SITE PLAN REVIEW / ADJUSTMENT CASE NO. SPR-ADJ16-06

APPLICATION NO. : 15-122545-RP & 15-122543-ZO

SUMMARY: A proposal to construct a 1,175 square foot addition to an existing office building. The existing development does not conform to the minimum landscape area requirement; however, 10 additional trees will be added to the existing landscaped areas.

Re: Plan Review, 1177 Center St. NE
15-122543-RP & 15-122545-ZO

DEMOLITION & FLOOR PLAN

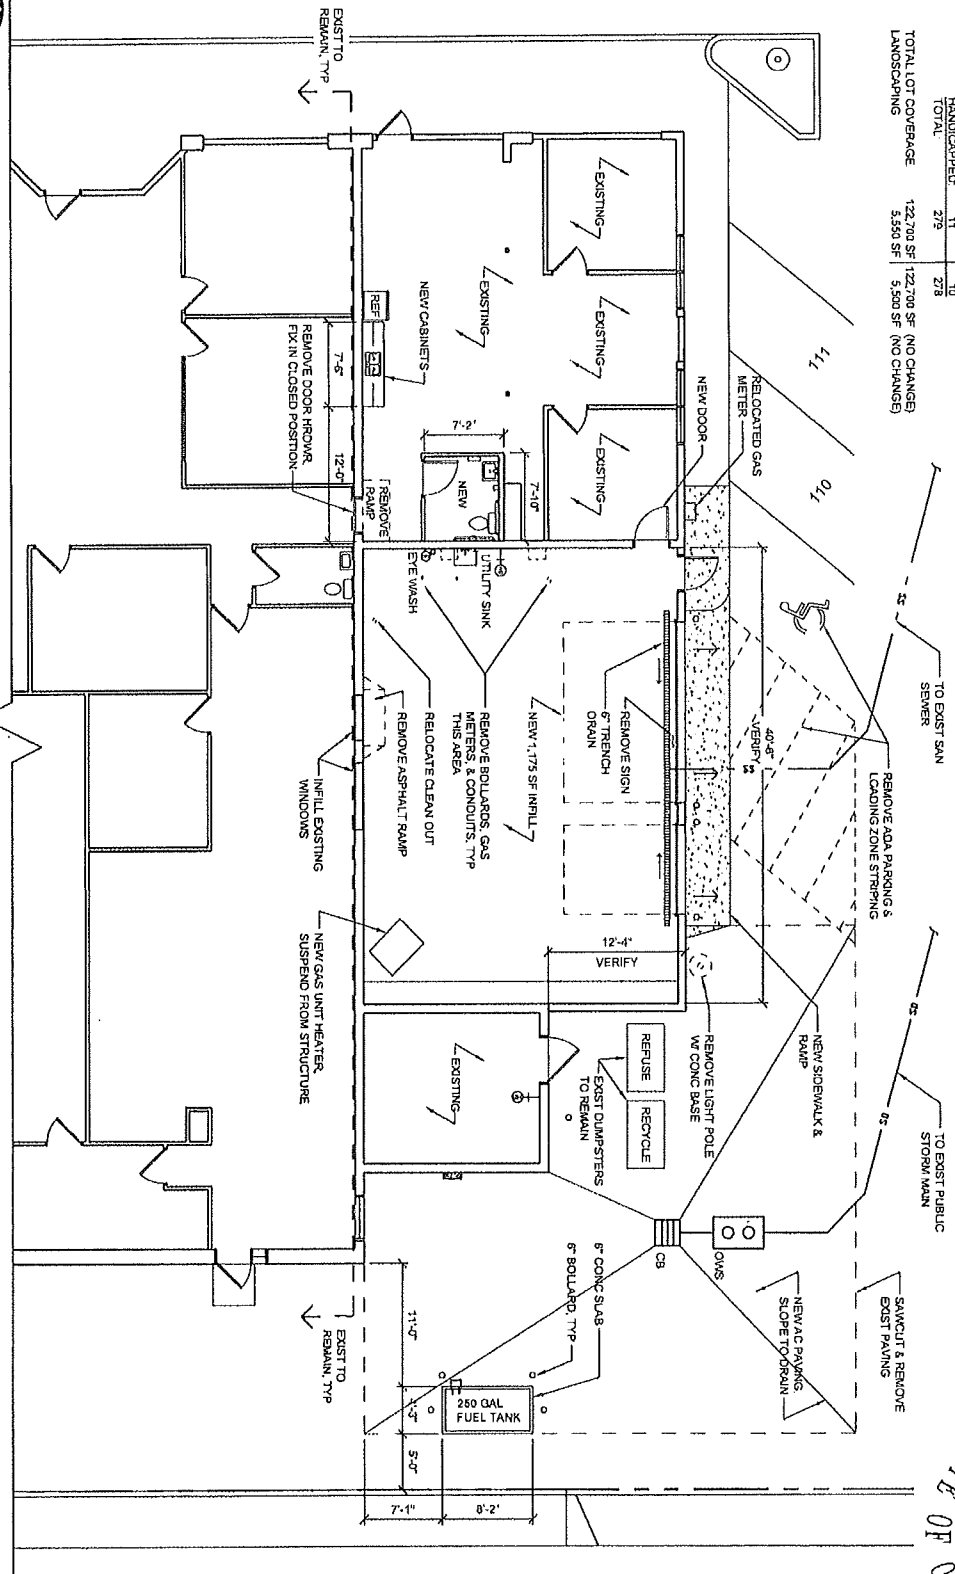
Staff Response: The applicant's site plan does not indicate bicycle parking. To ensure compliance with this standard, the following condition is necessary:

Condition 1: A bicycle rack to accommodate 2 bicycle spaces shall be provided.

PROPOSED LANDSCAPE PLAN

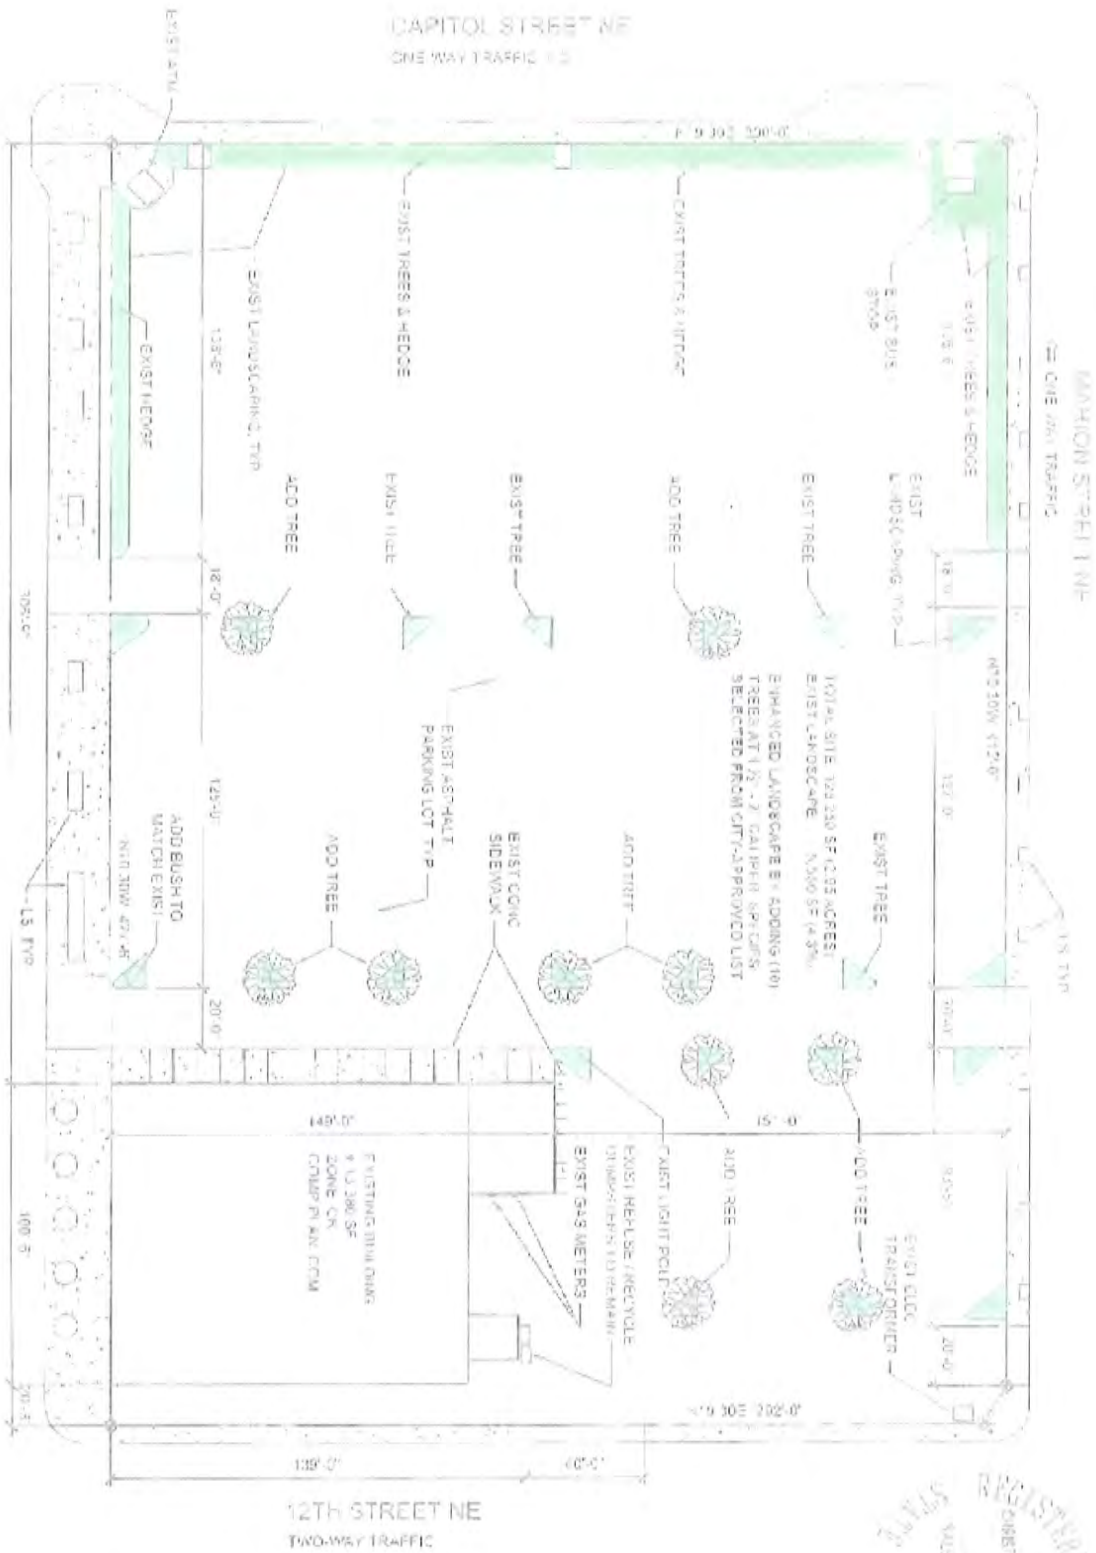
The intent of interior landscaping is to create a canopy effect and to break up expanses of paving and long rows of parking spaces. Trees for interior landscaping are to be deciduous shade trees. The proposed landscaping plan does not indicate the type of trees.

Condition 4: New trees indicated on the Landscaping Plan shall be deciduous shade trees.
